**ACT MATERIALS RECOVERY FACILITY**

# ADDENDUM TO APPENDIX Q BUSHFIRE RISK ASSESSMENT REPORT

Prepared for Veolia Environmental Services (Australia) Pty Ltd | 11 August 2025

**Figure 3: GHD Concept Plan**

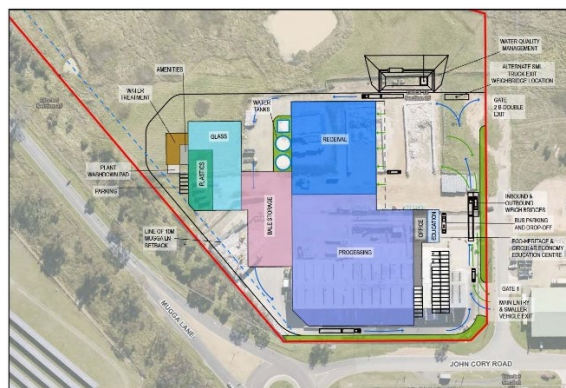
Veolia has made changes to the proposed site layout and design of the MRF to achieve operational efficiencies (refer Figure 2 & 3).

**Map 6 - Asset Protection Zone (APZ) Area Identified & Recommended - 6/08/25**

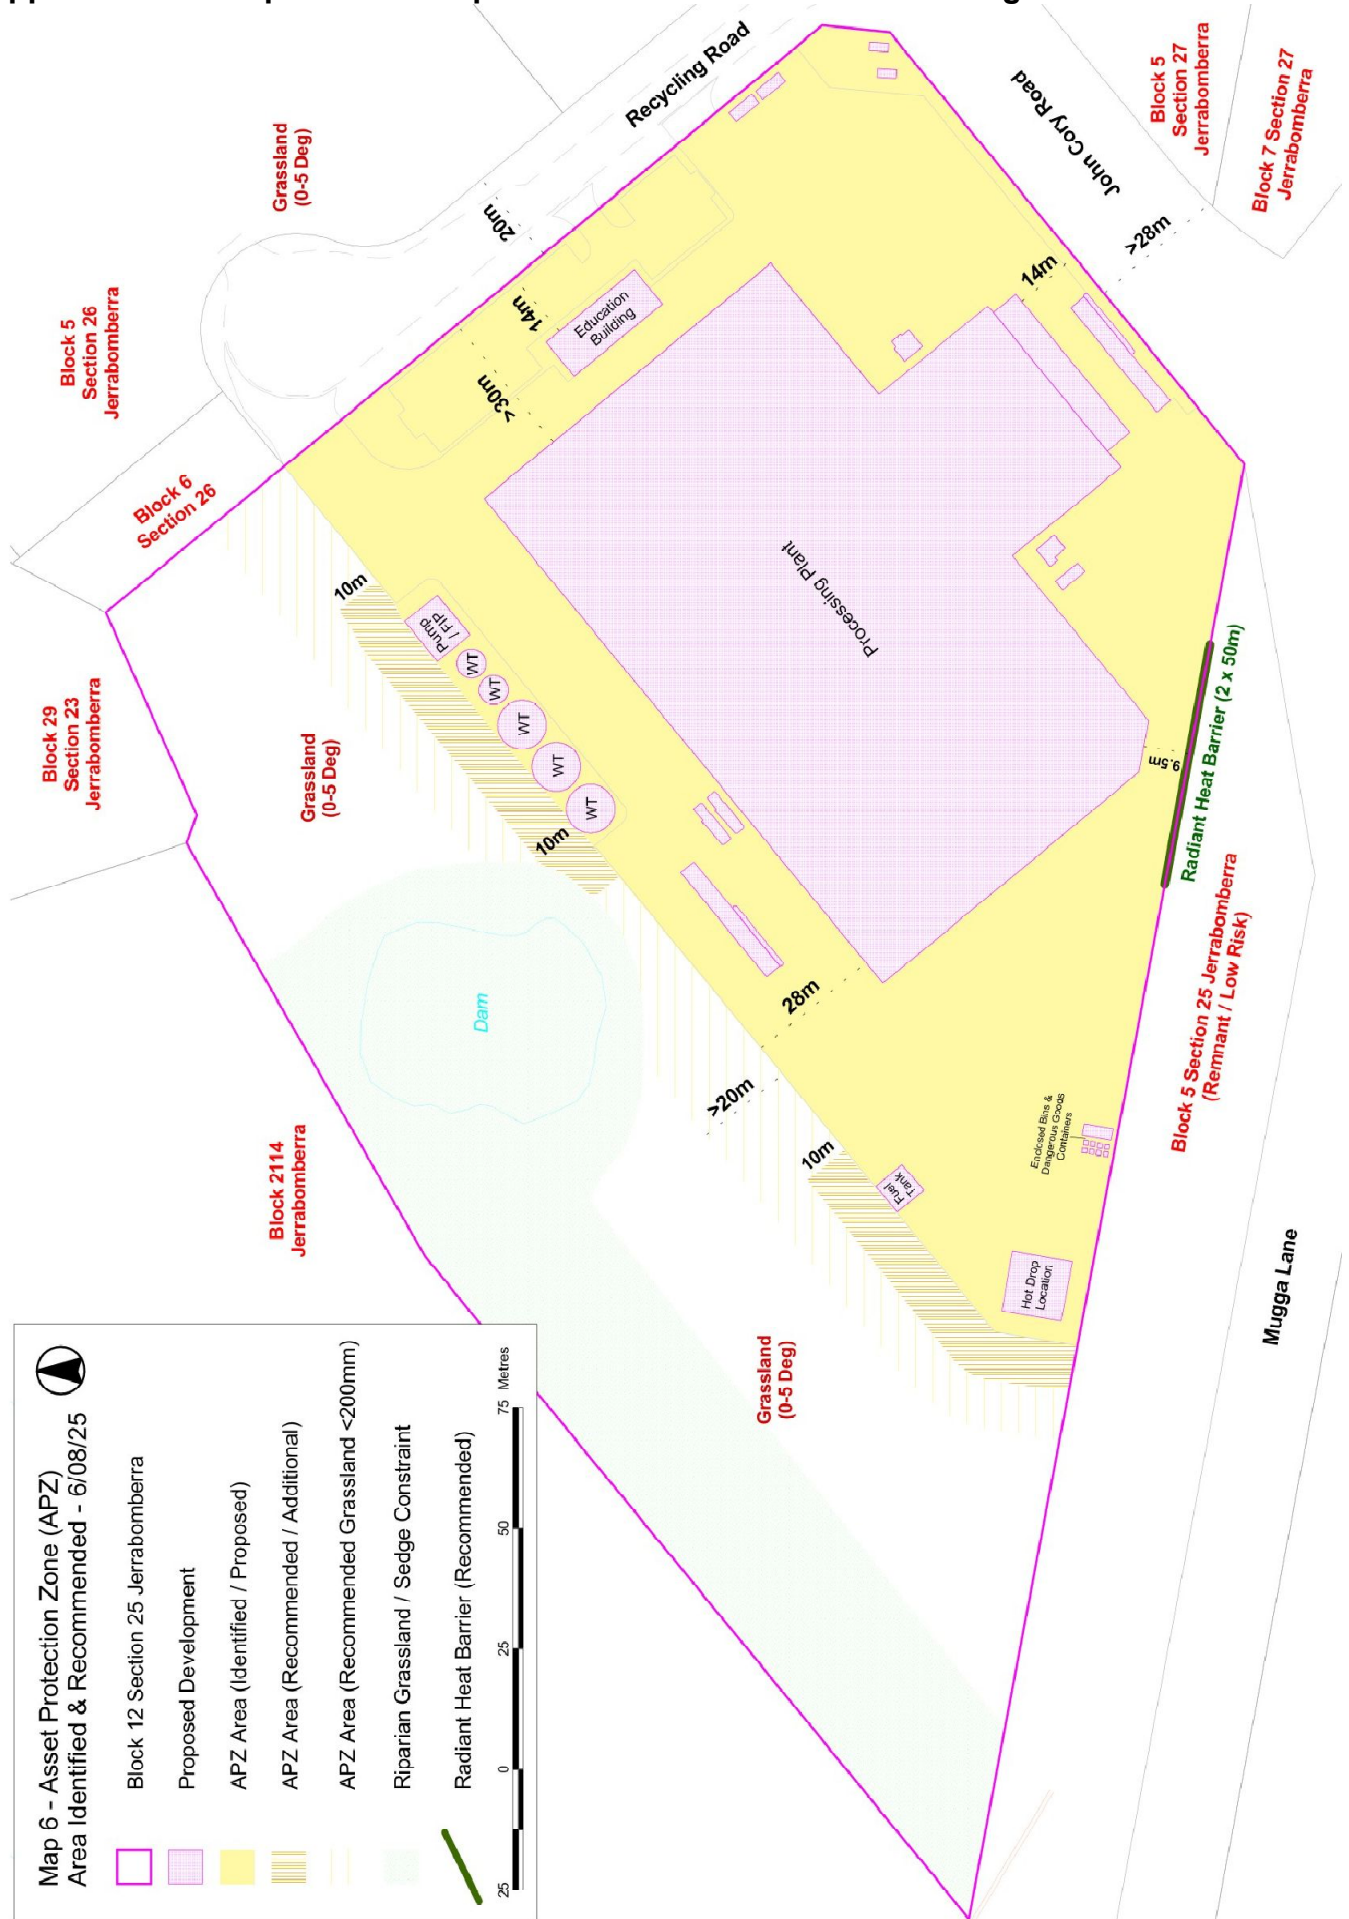
- 4) Excluding any area identified as riparian / grassland constraint, the subject property shall be identified and maintained as an APZ area from the building lines of the processing plant component for at least 50m or to the boundary of the block if a lesser distance.

- 5) Excluding any area identified as riparian / grassland constraint, any retained natural vegetation (grassland) and/or landscaping within direct vicinity (<50m) of the processing plant component shall be maintained as an APZ for the life of the proposed development and in accordance with Appendix 4 of the BMS. This would primarily include maintaining any retained grassland to <200mm in height, particularly during the bushfire danger period.

- 7) A 2m high non-combustible and solid barrier (e.g. colourbond fencing) shall be located along the southern boundary of the subject property to neighbouring Block 5 Section 25 Jerrabomberra (vegetated screening to Mugga Lane) to shield the processing plant component from any remnant woodland / scrub or unmanaged grassland within 20m of the building line.
